**Design Review & Historic Preservation Board
Agenda
July 14, 2022**

Design Review and Historic Preservation Board
Minutes
June 23, 2022

REAR ELEVATION

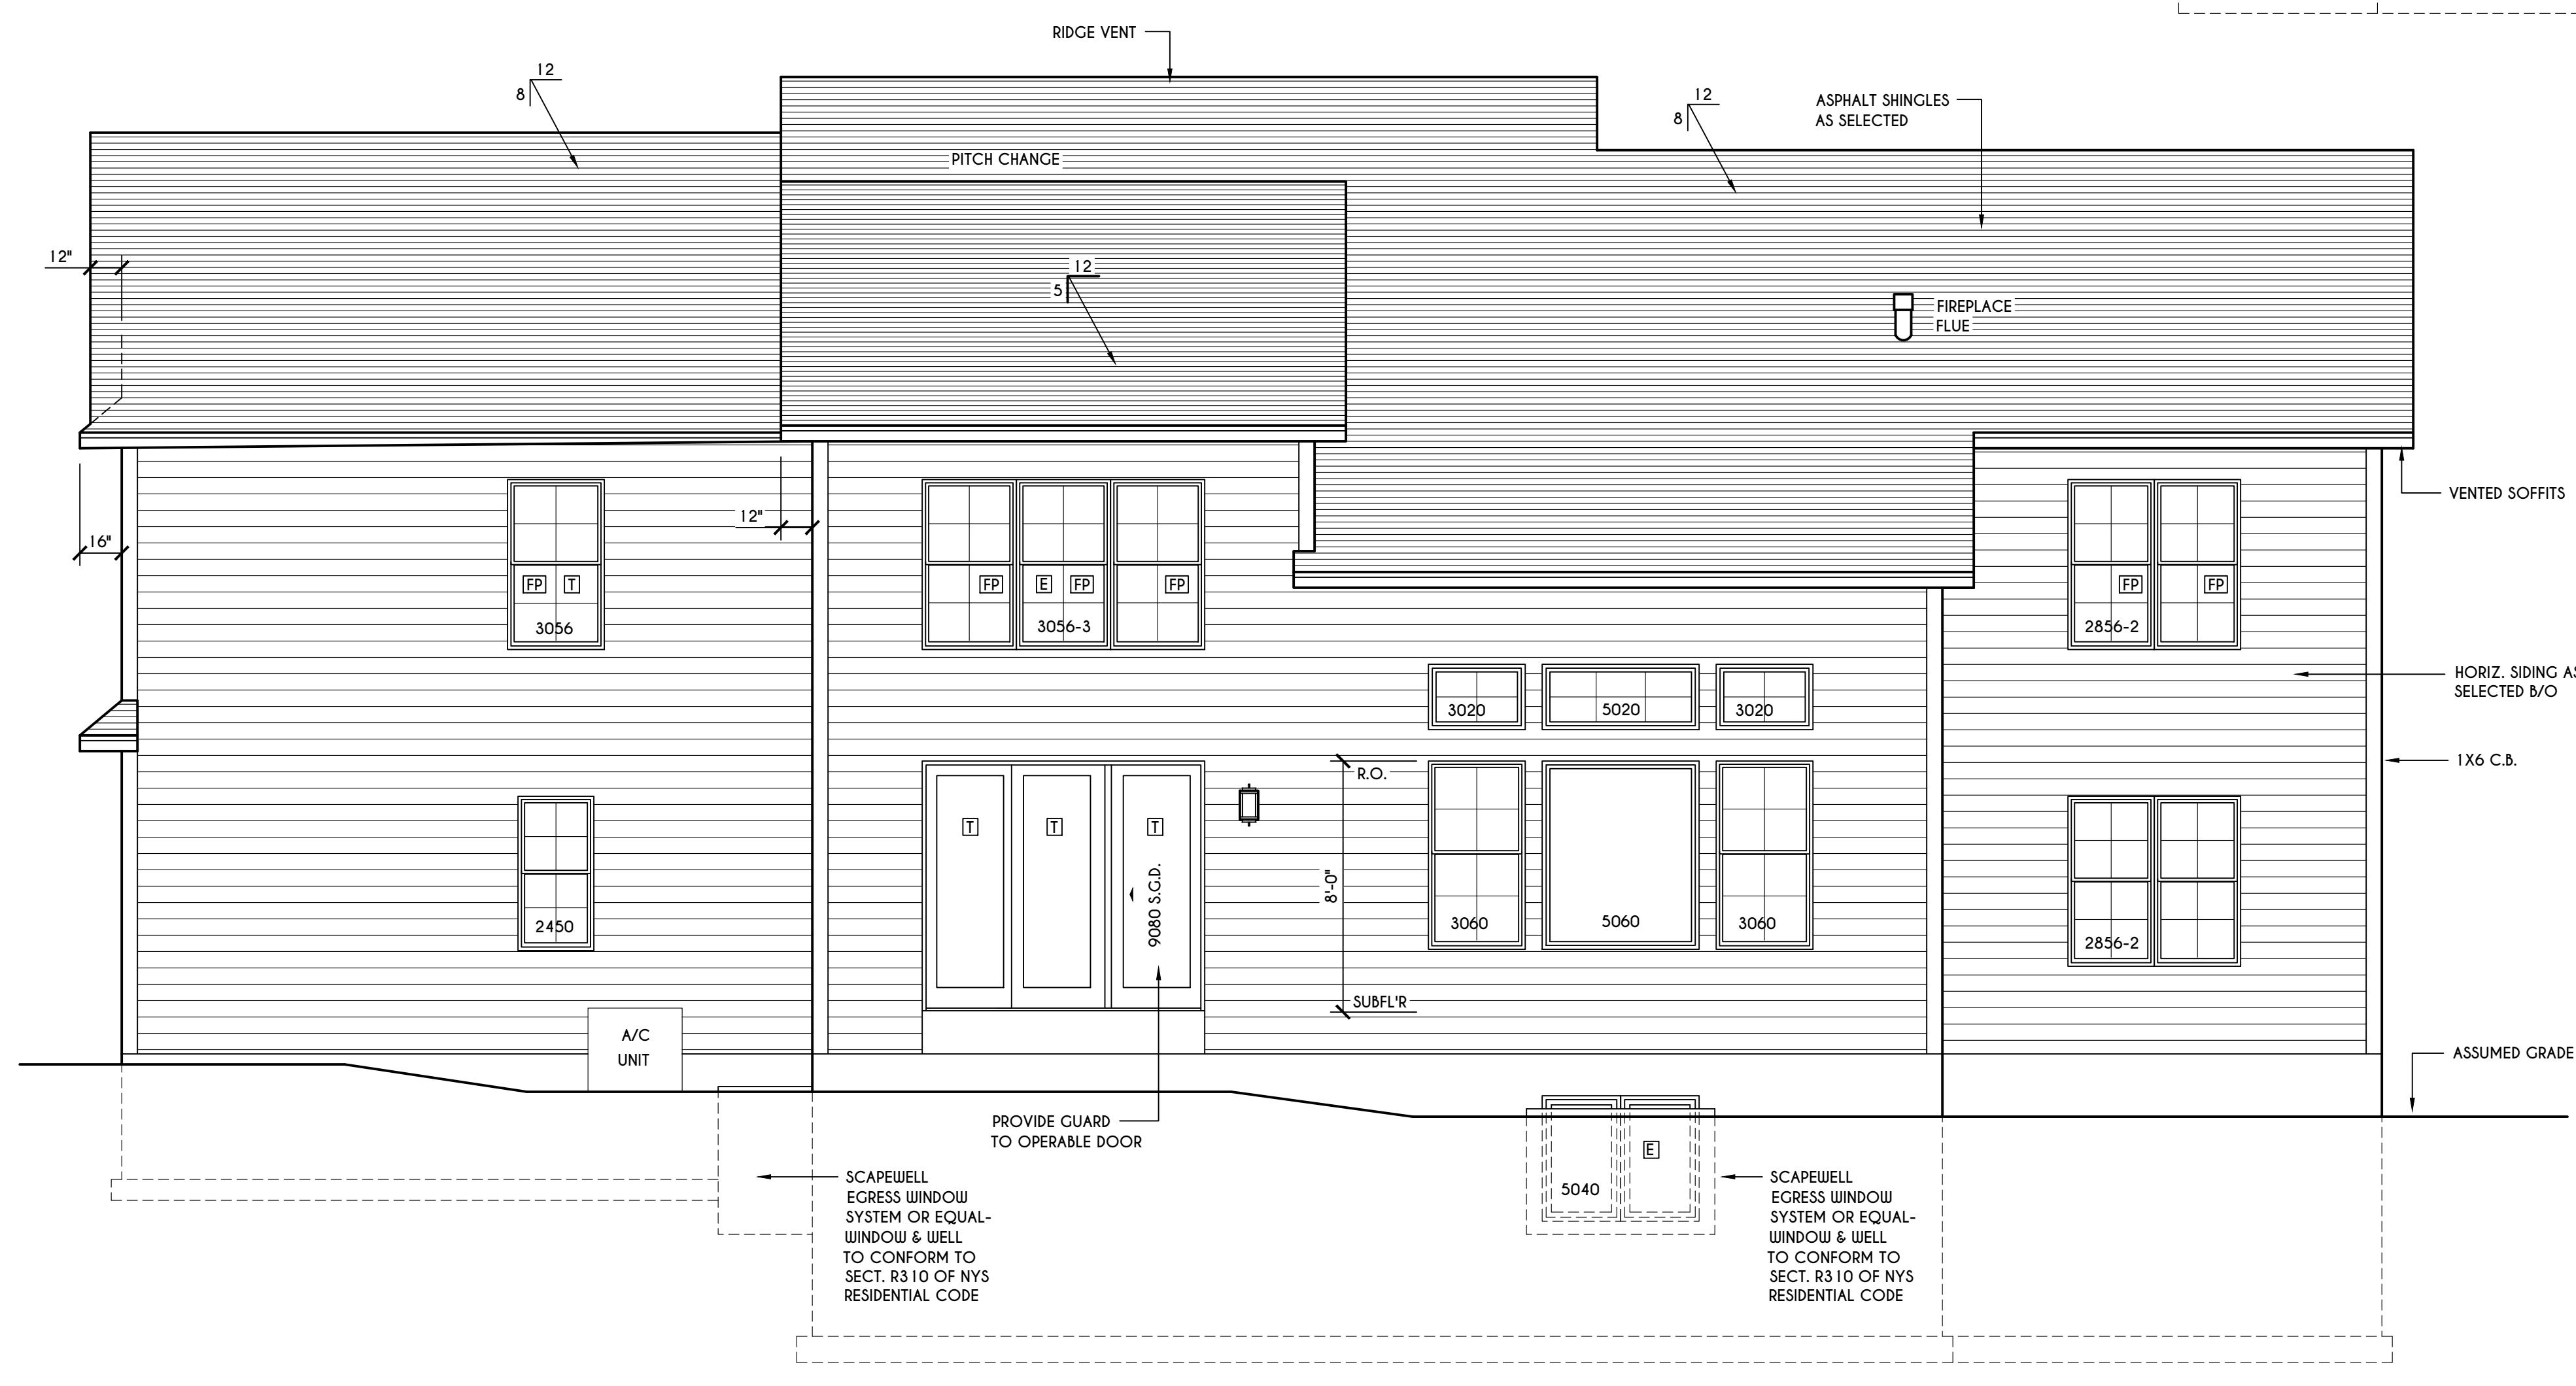
The Board drew attention to the cantilevered fireplace and the massing of the left side of the rear elevation. They would like to see a window added to match the other small window closest to the left side of that elevation.

1. Two brackets to be added below the fireplace if the grade is lower than 24".
2. A double hung window to be added at the garage rear elevation.

Original Submission

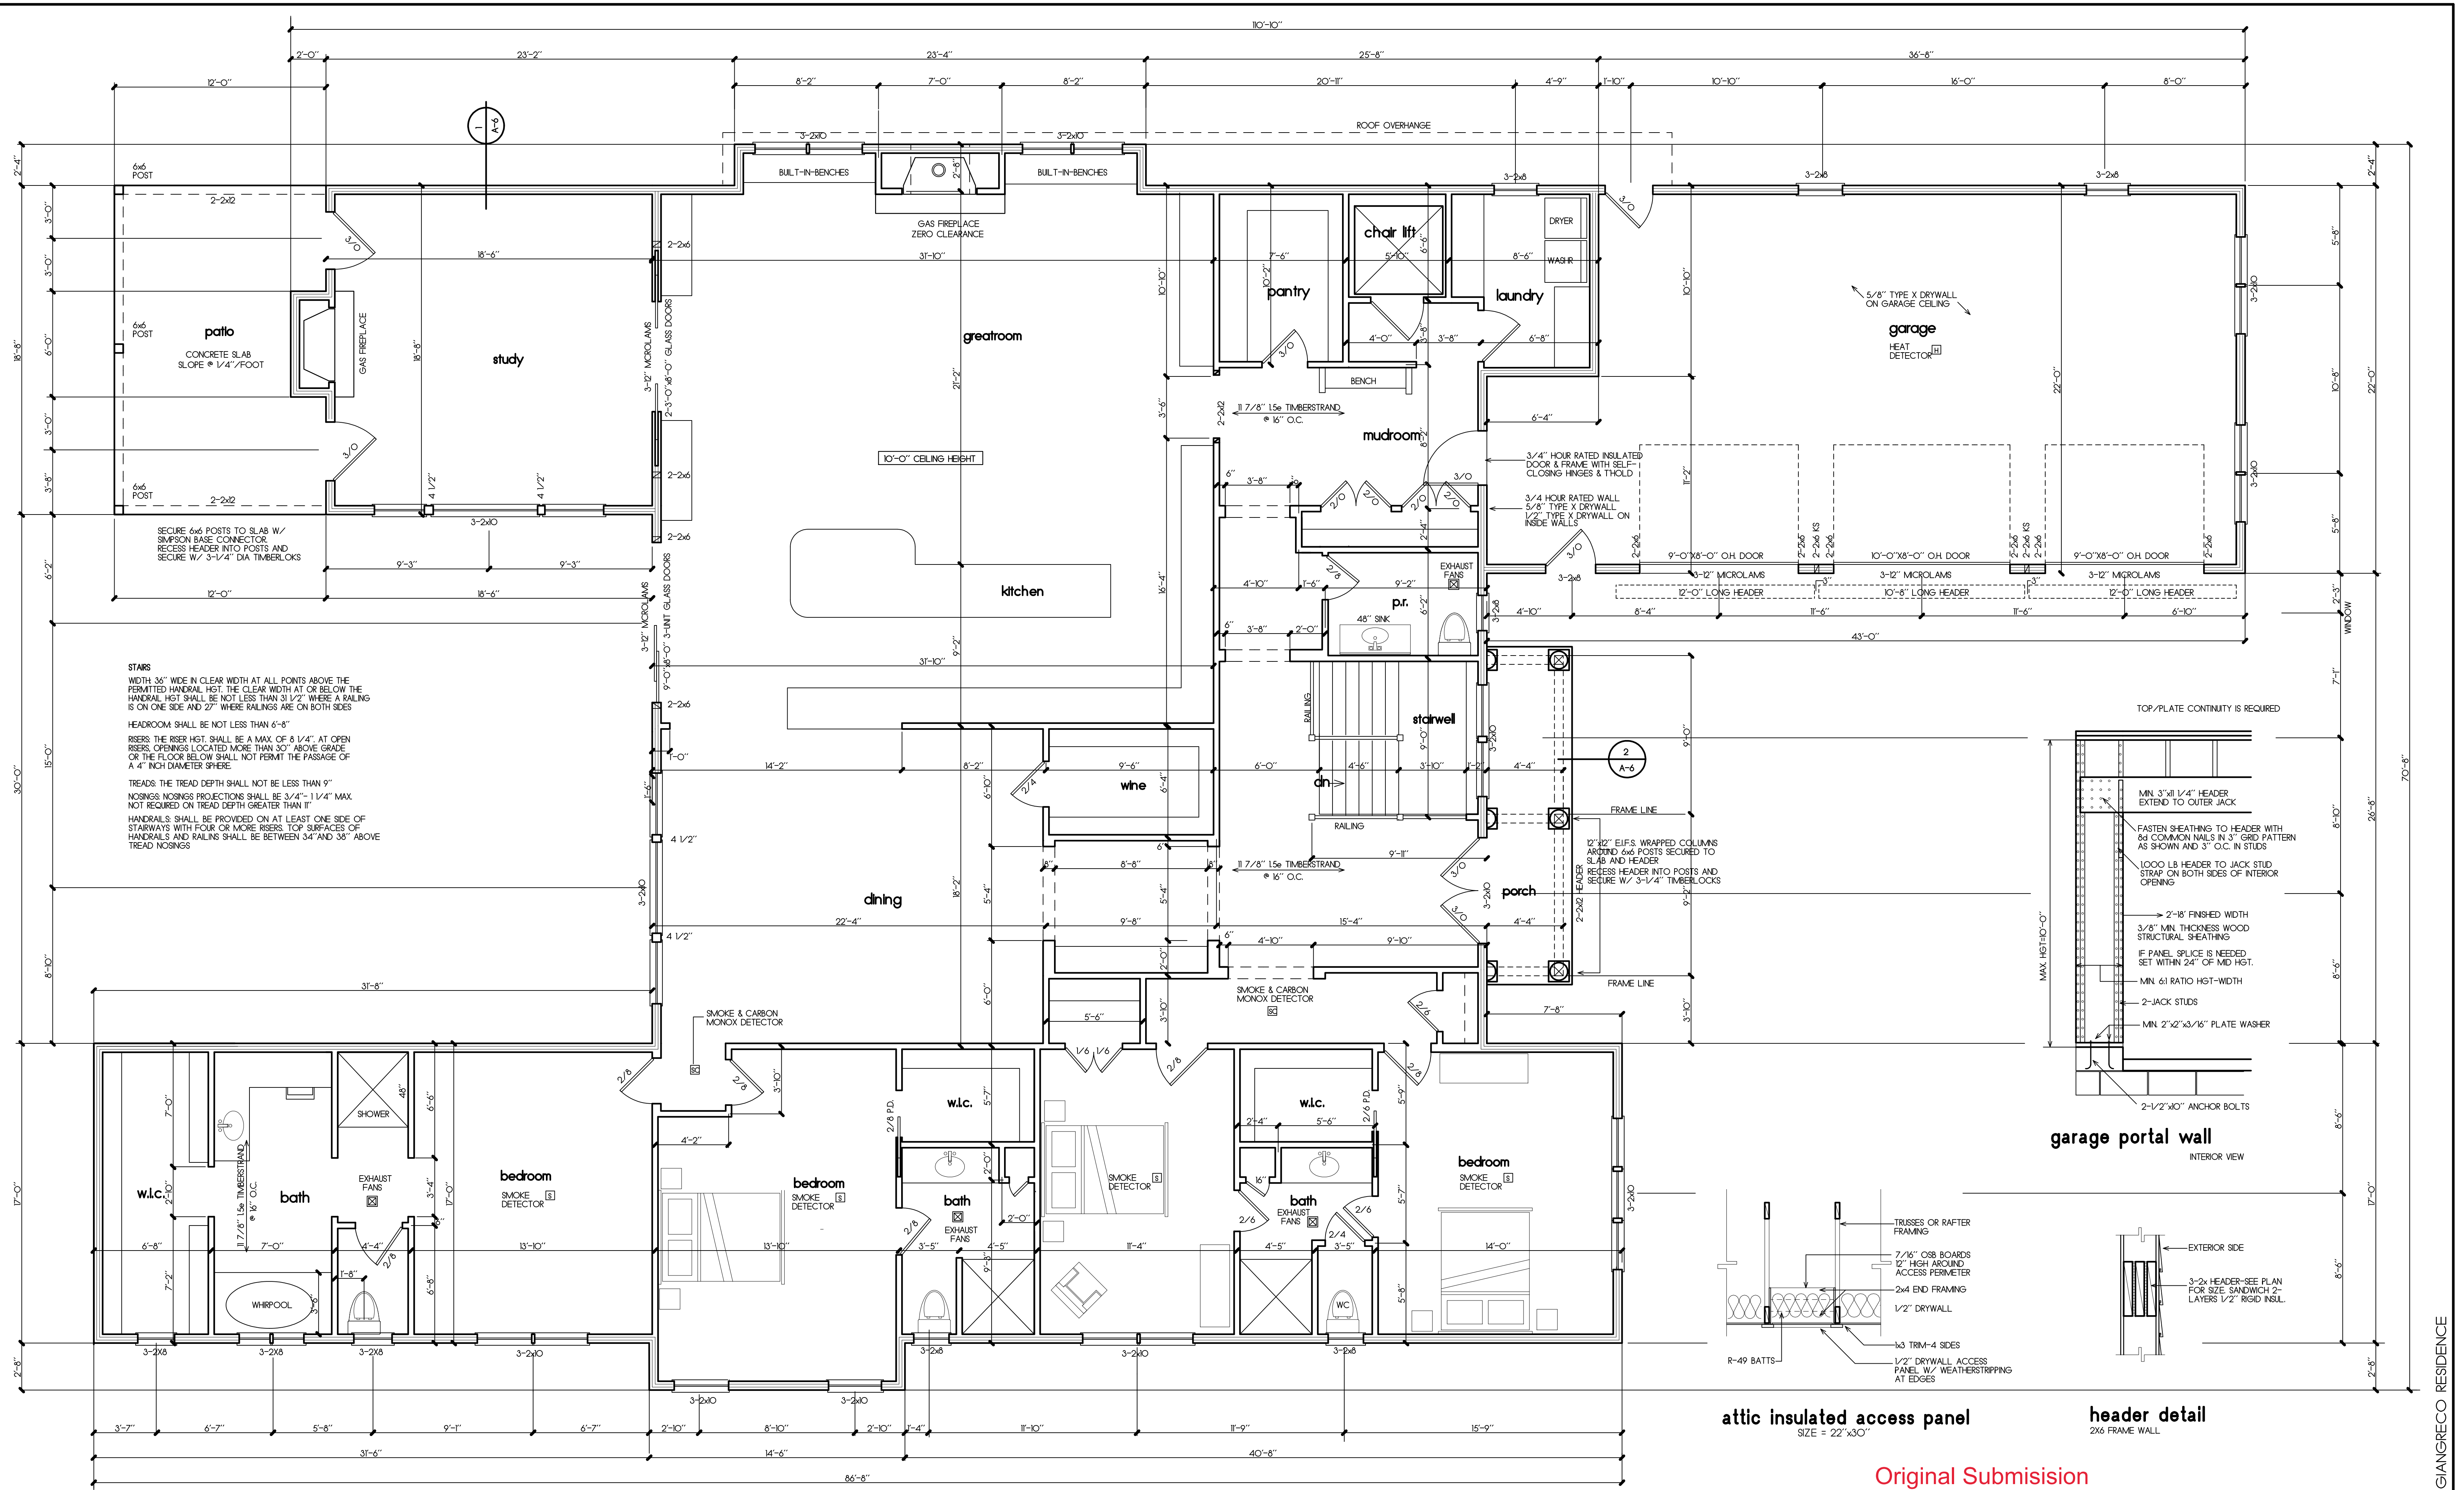
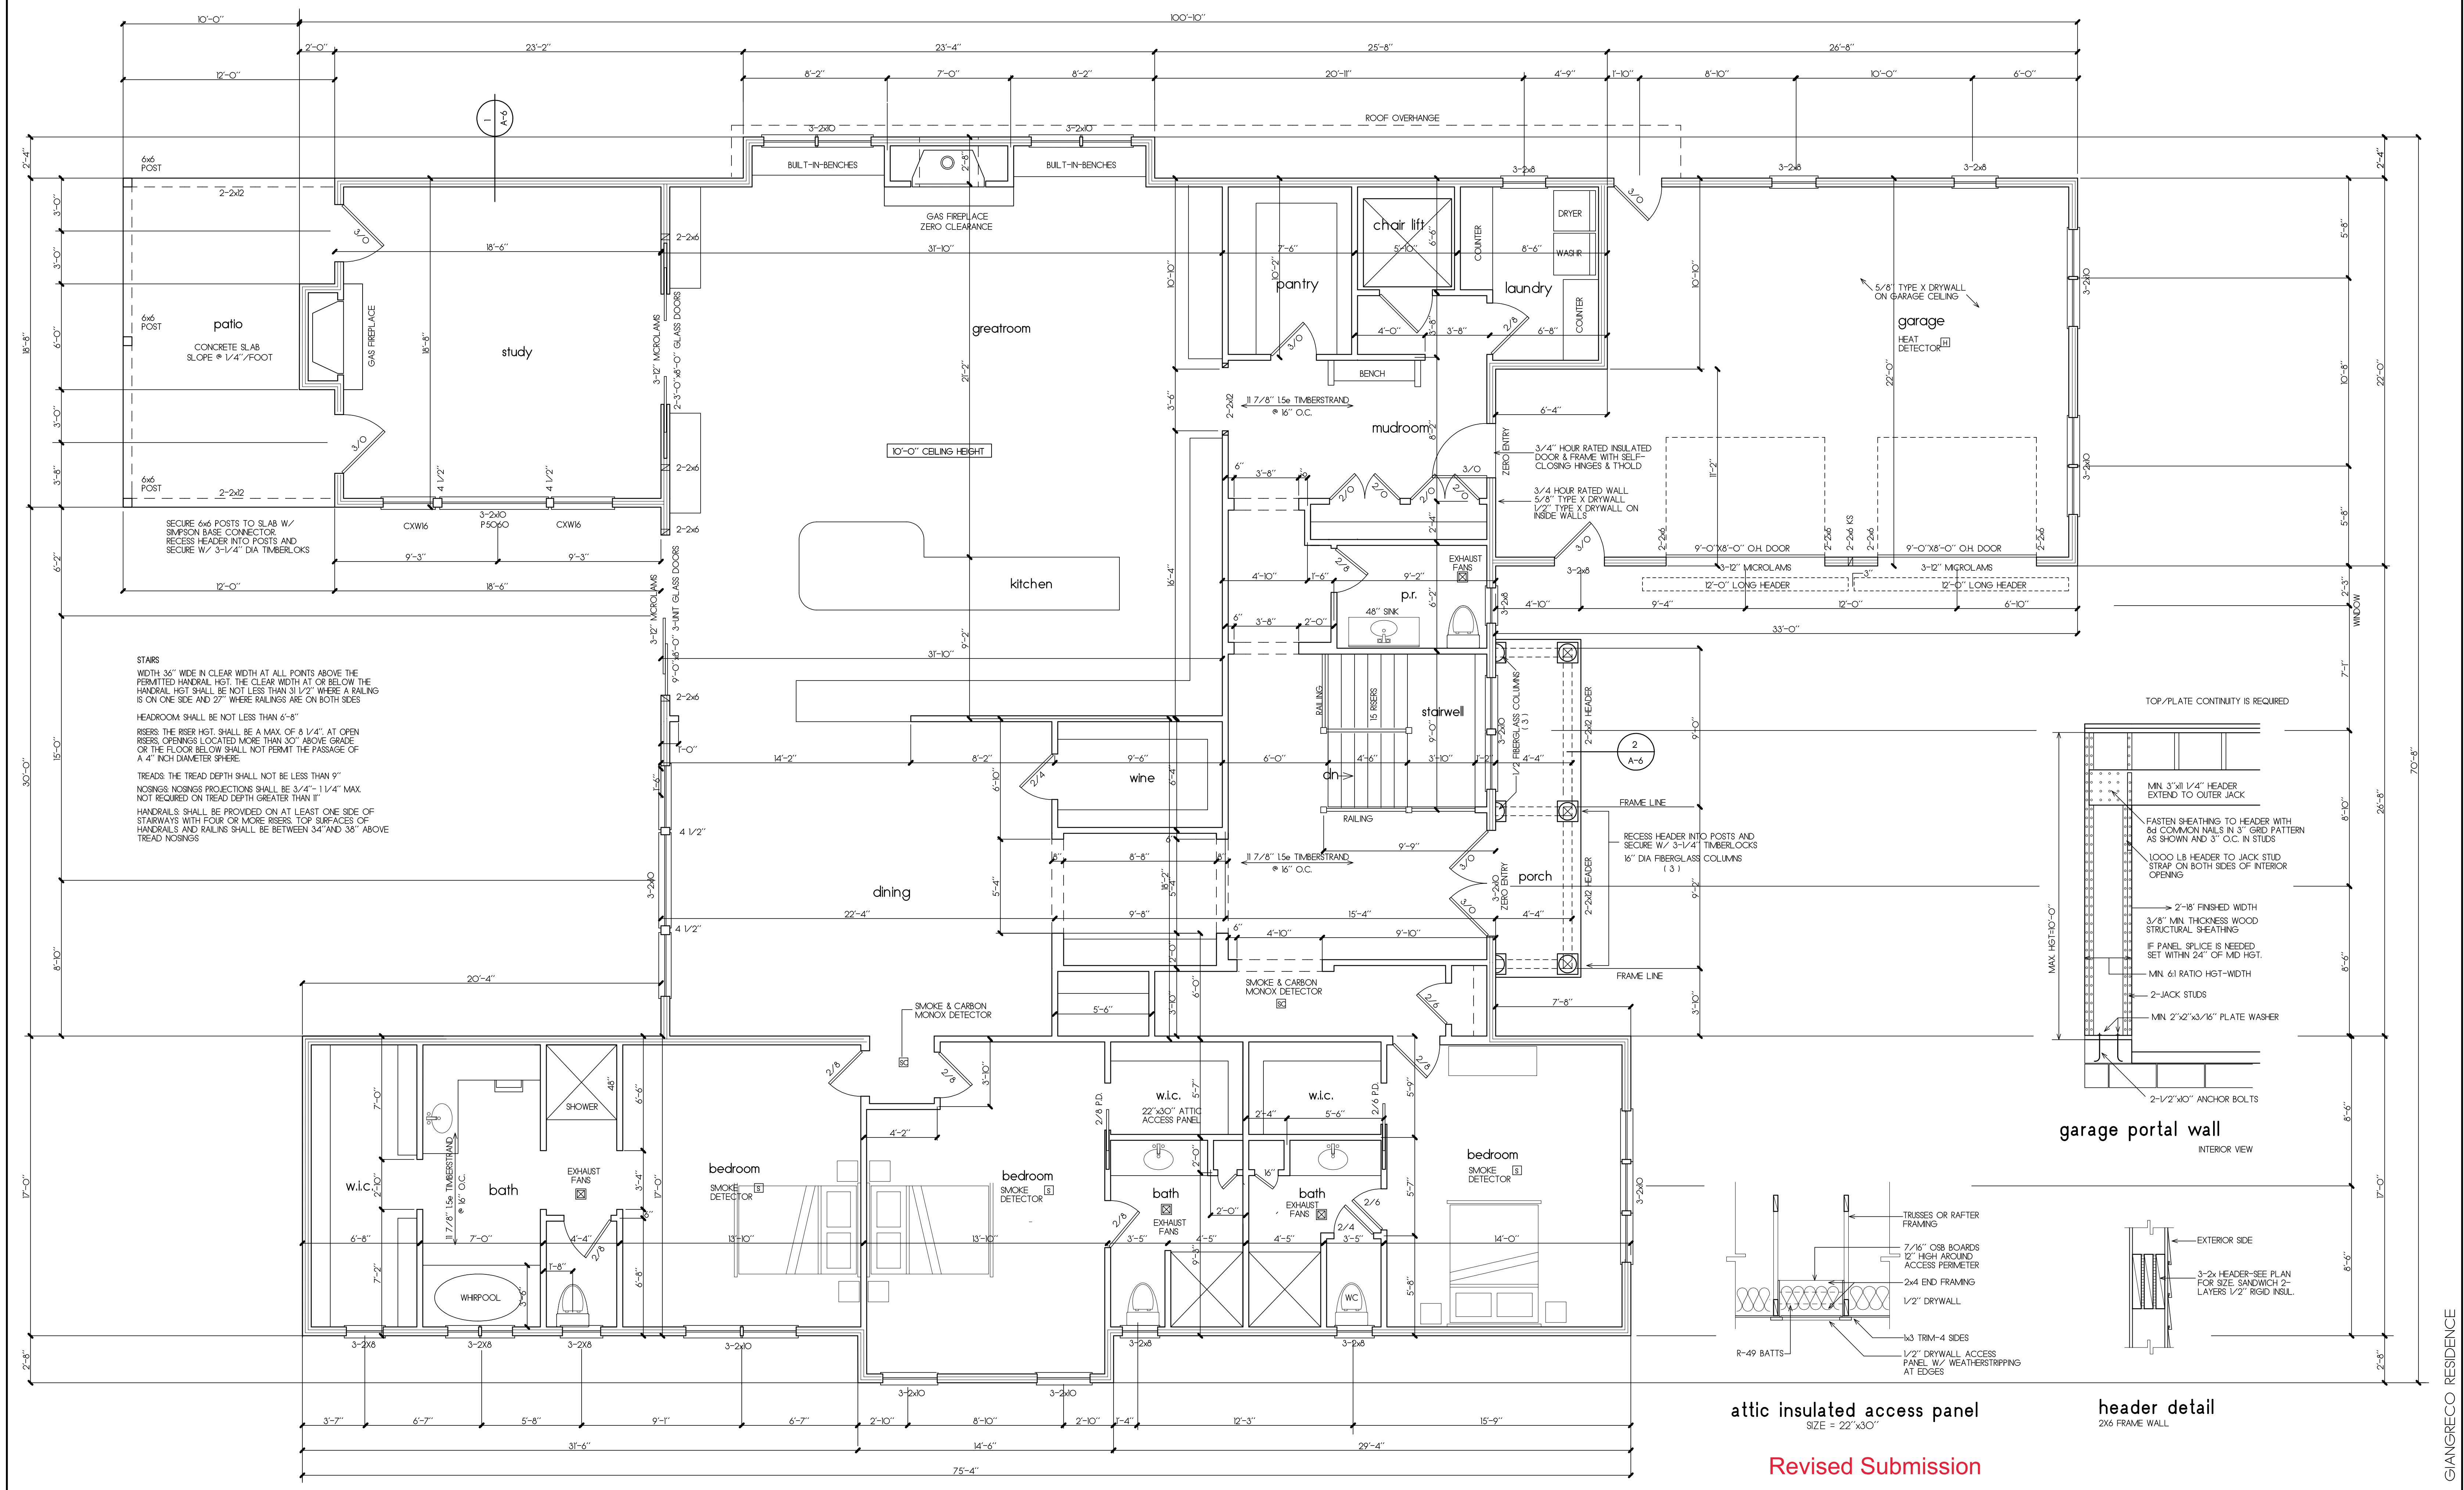
The Board discussed the plans and facts presented to them. Dirk Schneider discussed that the new plan more than doubles the current footprint. He stated that the garage in front, despite the courtyard design, points to dissimilarity in the neighborhood. He felt the siding is a departure from the neighborhood but held some interest as a material. Bonnie Salem indicated that she would like to review a comparison of the sizes of other homes in the neighborhood. A discussion of sizes and square footage of other homes in the neighborhood was then held. It was noted that this property at 93 Kilbourn Road has more acreage than some and lot sizes vary on the street.
